# Wheeler Kearns Architects

Subject: PC #16-014 Round 1 Comments: Variation and Special Use Permit Application at 1234 N Arlington Heights Road

*Our Saviour's Lutheran Church*  
Arlington Heights, Illinois

COLUMBARIUM PHOTOMETRIC STUDY  
SCALE 1/8"=1'-0"

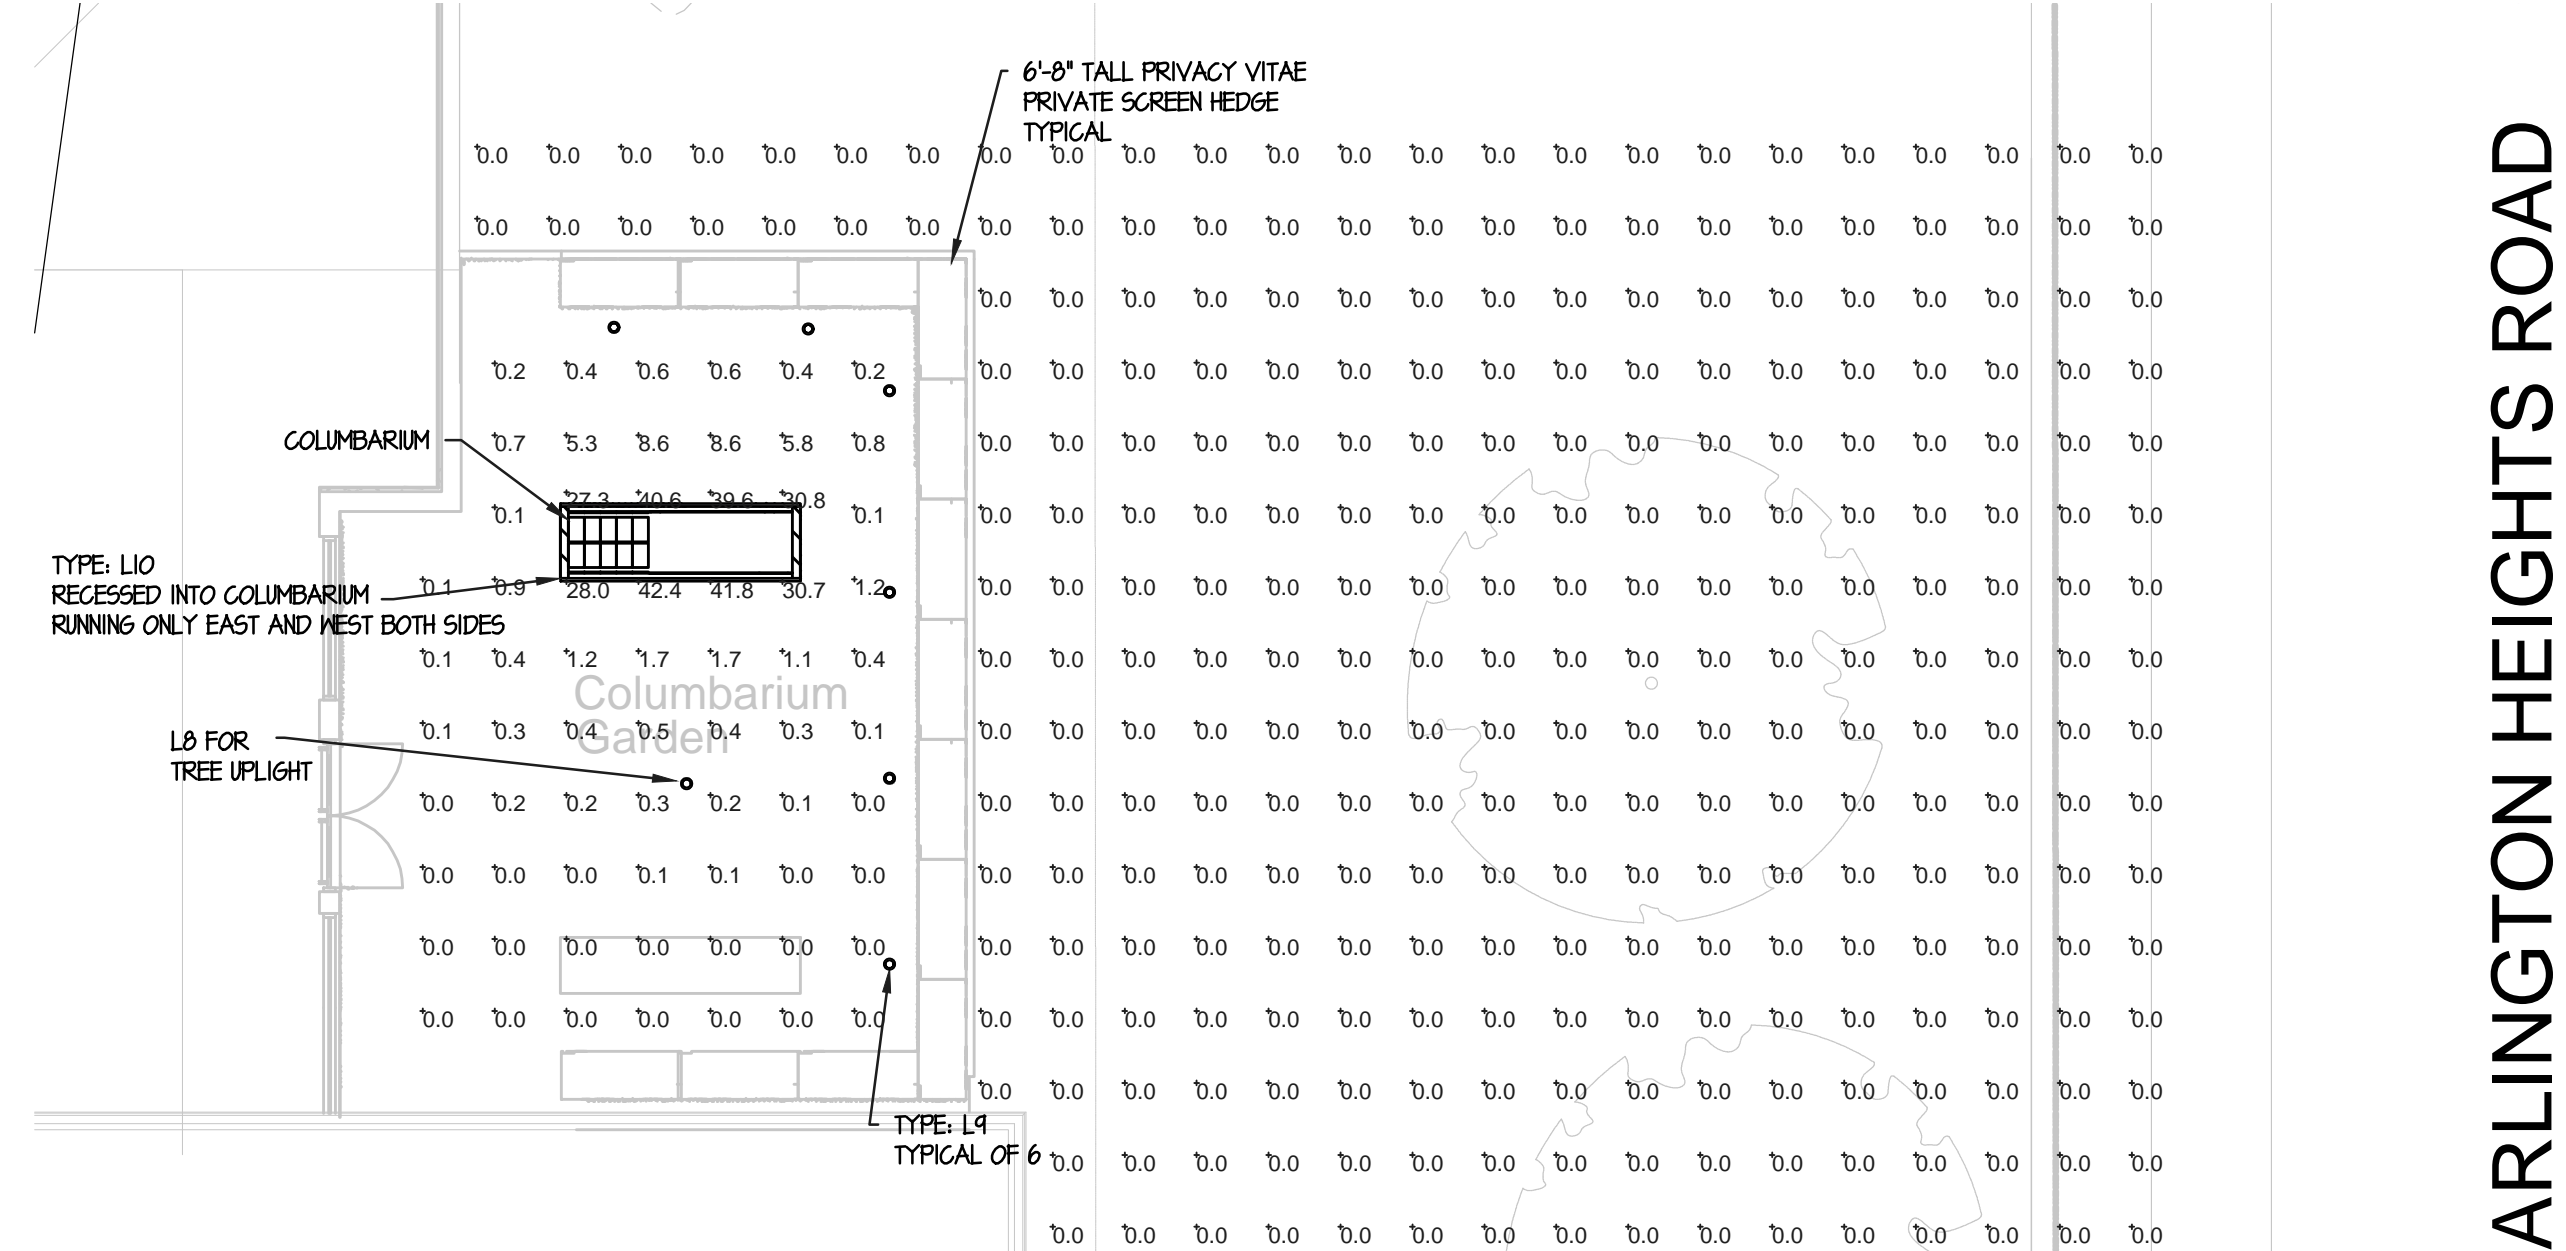
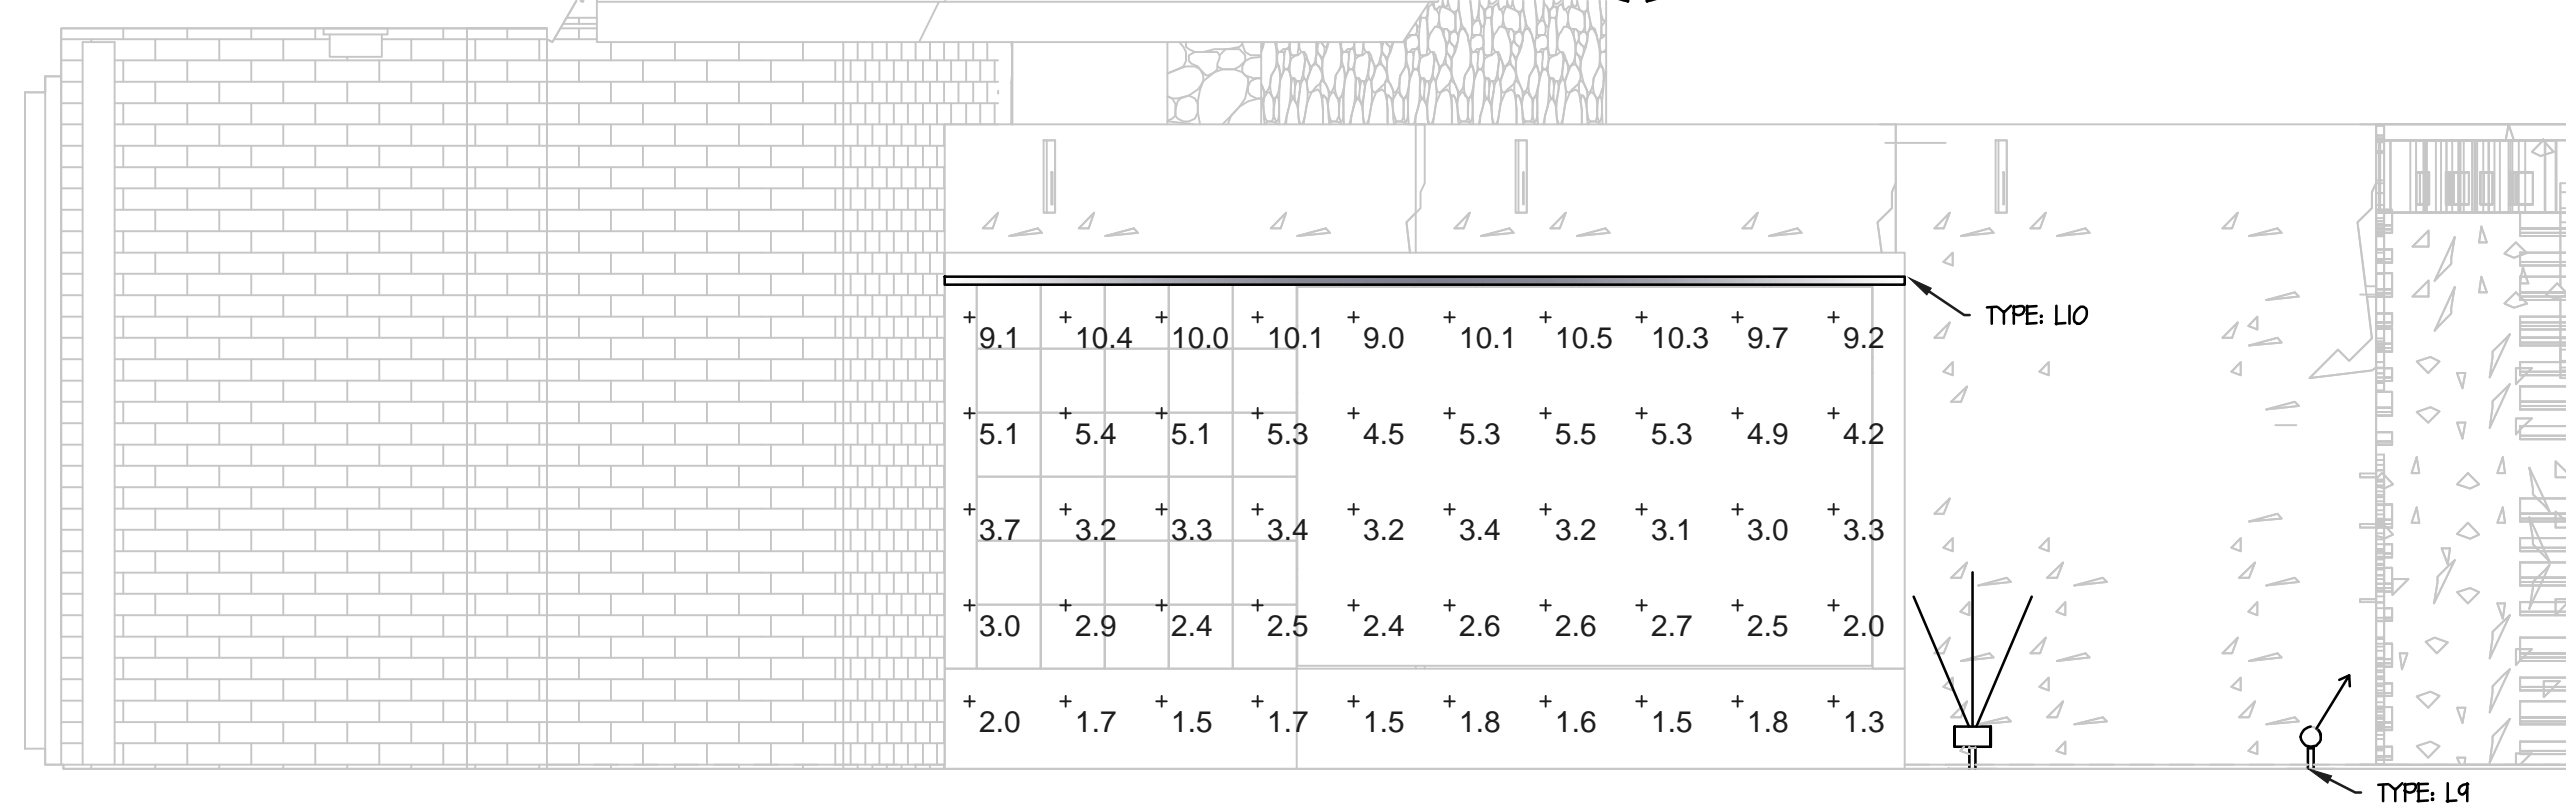
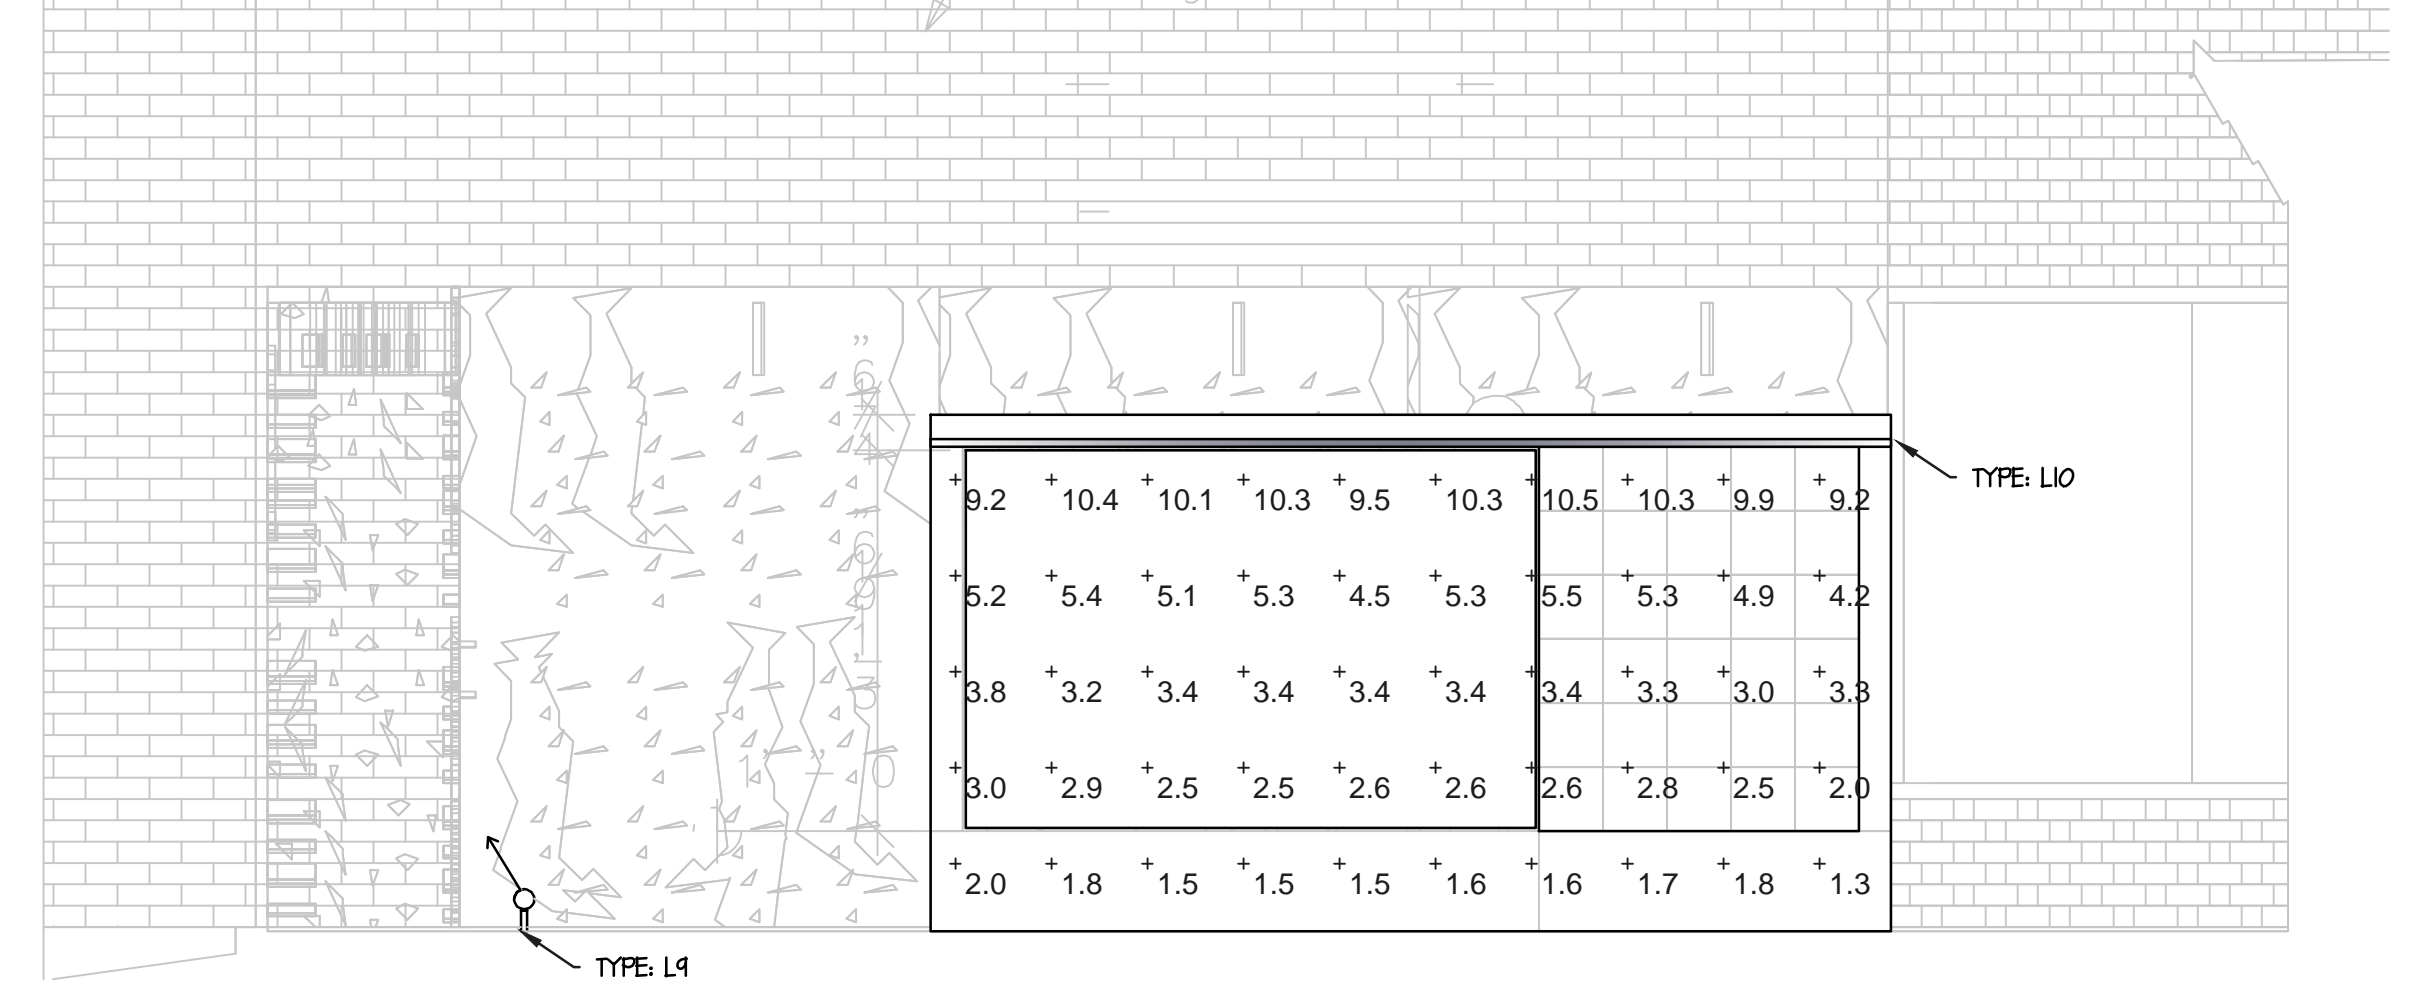
Police Department	2	Are lighting requirements adequate for safety?	Surfaces within proposed Columbarium shall be lit, including inside of landscaping, surfaces of Columbarium itself, ground surrounding bench, and the area underneath the ornamental tree, as well as light spilling from the interior of the building. The design intent is to illuminate faces, but that space is not so bright as to invite attention from the street. An exterior wall mounted motion activated light fixture shall be installed by the exterior entrance to the proposed Columbarium, and a security camera will be focused on the exterior entrance.
	6	(a) Emergency contact information card	Enclosed
